ADDENDUM 1 to ITB WS 34-19

April 12, 2019

BEASLEY PARK SEWER IMPROVEMENTS PROJECT

ELECTRICAL EQUIPMENT RACK
 NOT TO SCALE

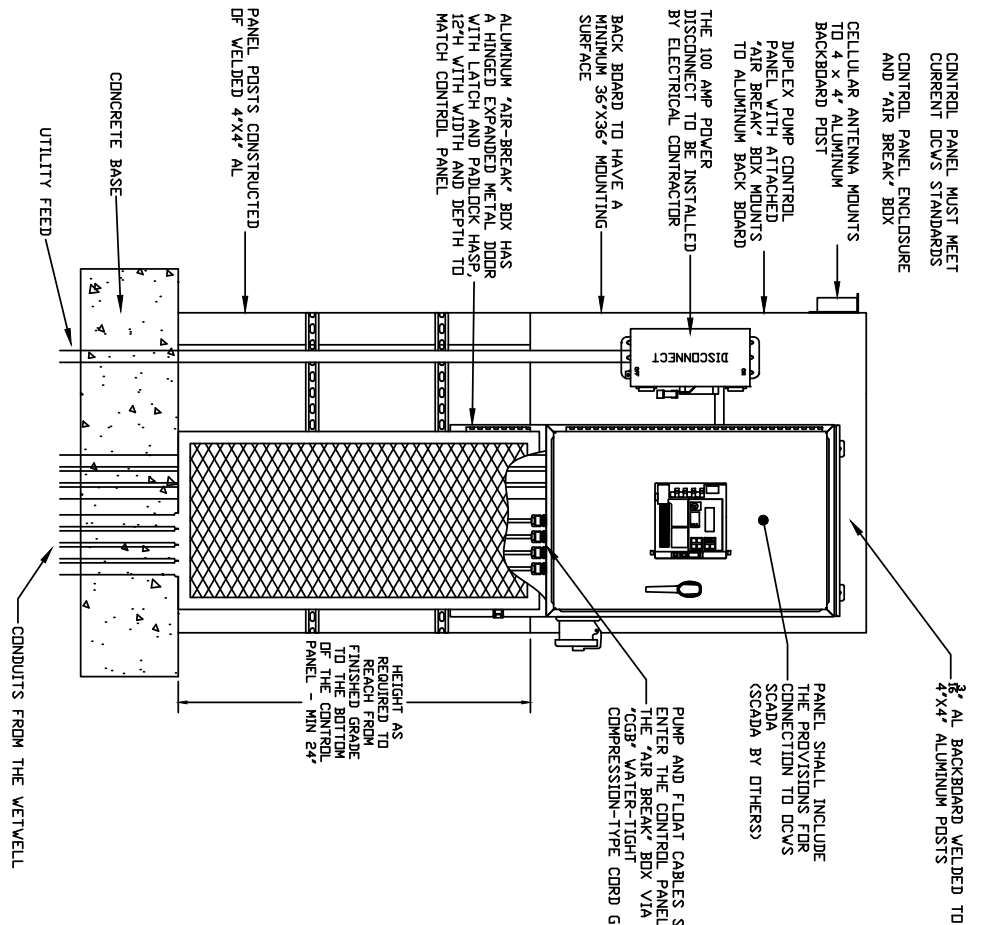
Question 5: There are two different details of the electrical equipment layout. (see page E-1) Which is correct? One shows and air break box 12" H X 24" W X 12" D and the other shows the air break to be 30" tall X the width and depth of the control cabinet. Also one shows 3 legs, and the other shows 2 legs supporting the backboard. Please clarify which is the correct and preferred detail.

Response 5: See attached revised Drawing E 1.0

POLE MOUNTED FIXTURE
 DETAIL

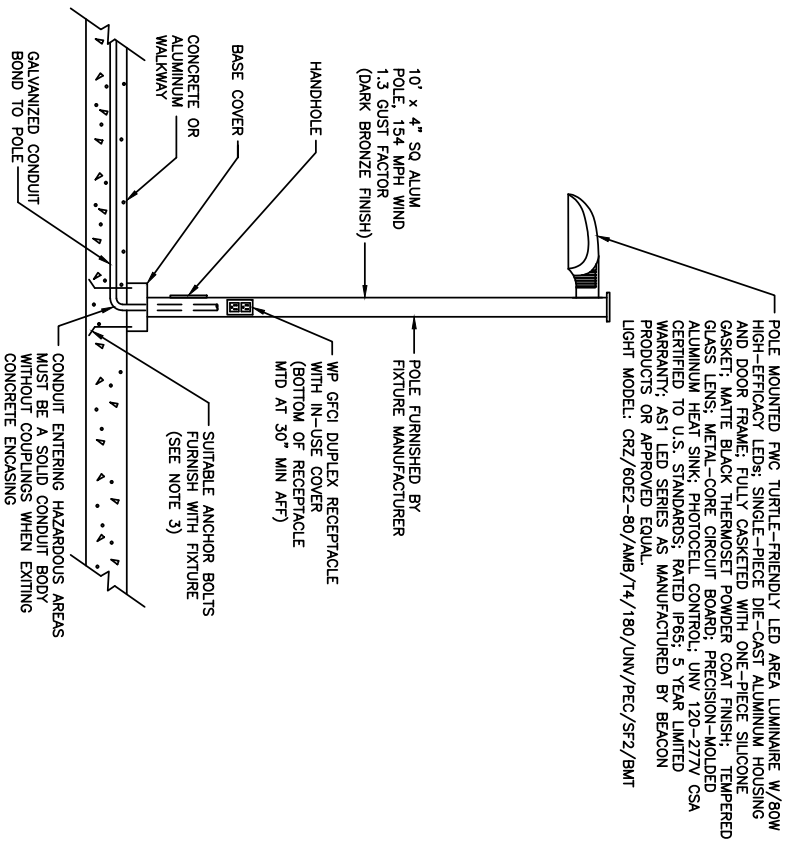
Question 6: Will the conduits coming from the wet well to the air break box require sealoffs or will duct seal be considered adequate? (Detail does not show anything.)

Response 6: Duct Seal will be adequate. The sealant should allow for easy removal for future removal of pump power cords.
